TECHNICAL SERVICE BULLETIN

TIE DOWN ENGINEERING changed the primary brake spring on the right side brake assembly to give the brakes a smoother action. Your brakes may have the older style spring (see below). Use the springs enclosed in the kit when replacing the brake shoes.

Old Style Brake Spring

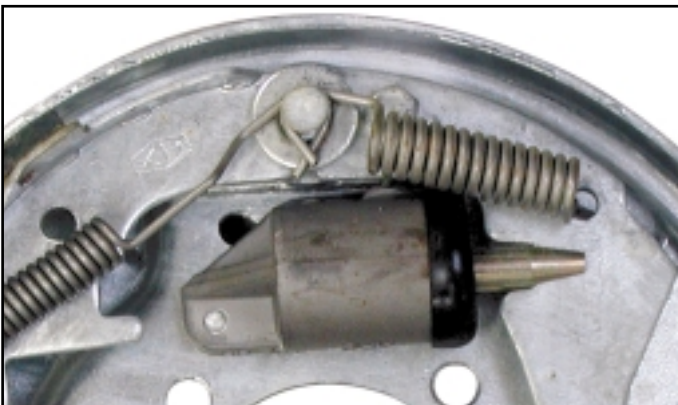
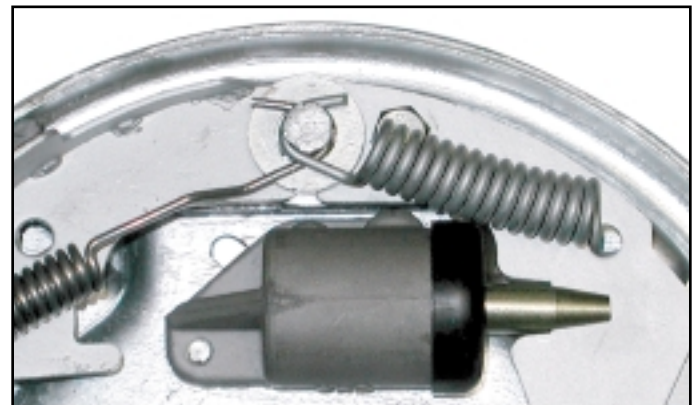
TIE DOWN ENGINEERING changed the primary brake spring on the right side brake assembly to give the brakes a smoother action. Your brakes may have the older style spring (see below). Use the springs enclosed in the kit when replacing the brake shoes.
